EXXON NUCLEAR COMPANY, Inc.
RESEARCH AND TECHNOLOGY CENTER
2955 George Washington Way, Richland, Washington 99352
PHONE: (509) 375-7100

Reference: Docket No. 71-9022

The Exxon Nuclear Company, Inc. is a registered user of the CE-250-2 package, Certificate of Compliance 9022. Routine use of the licensed package has indicated that improved utilization can be achieved by a modification of the inner package closure system. This letter, therefore, is to request your review, approval, and subsequent revision of Certificate 9022 to permit closure of the CE-250-2 package via either the currently licensed or proposed alternate closure system.

Figure 1
 Revision to View B of Combustion Engineering
 Drawing NFM-E-22175 - Alternate Closure System

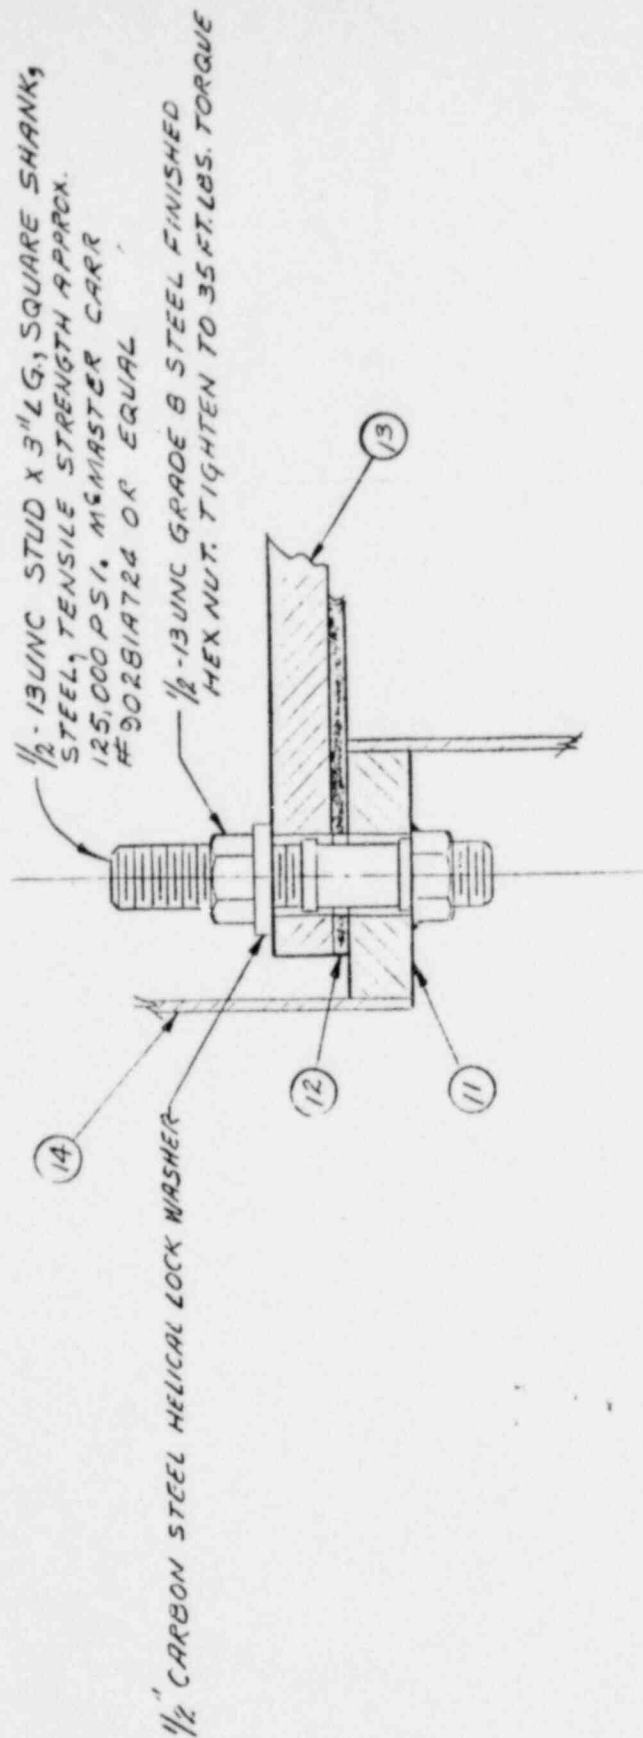
Part 5(a)(3) of Certificate of Compliance No. 9022 references Combustion Engineering Company, Inc. drawing NFM-E-Z2175, Revision 00. View B of that drawing indicates the typical closure bolting arrangement. In the case shown, a bolt is inserted through the inner lid and attached via a nut which is tack-welded to the back of the flange. The alternate arrangement for which your approval is requested is shown in the attached figure. In that proposed closure system, a stud would be threaded into the existing nut located on the back of the flange and closure would be accomplished by the use of a helical lock washer and nut arrangement.

The optional closure system proposed herein utilizes part of the existing system and, where replacement parts are proposed, the strength of the new parts meets or exceeds that of the replaced components. Consequently, continued compliance of the proposed alternate closure system with the requirements of 10 CFR 71 is assured.
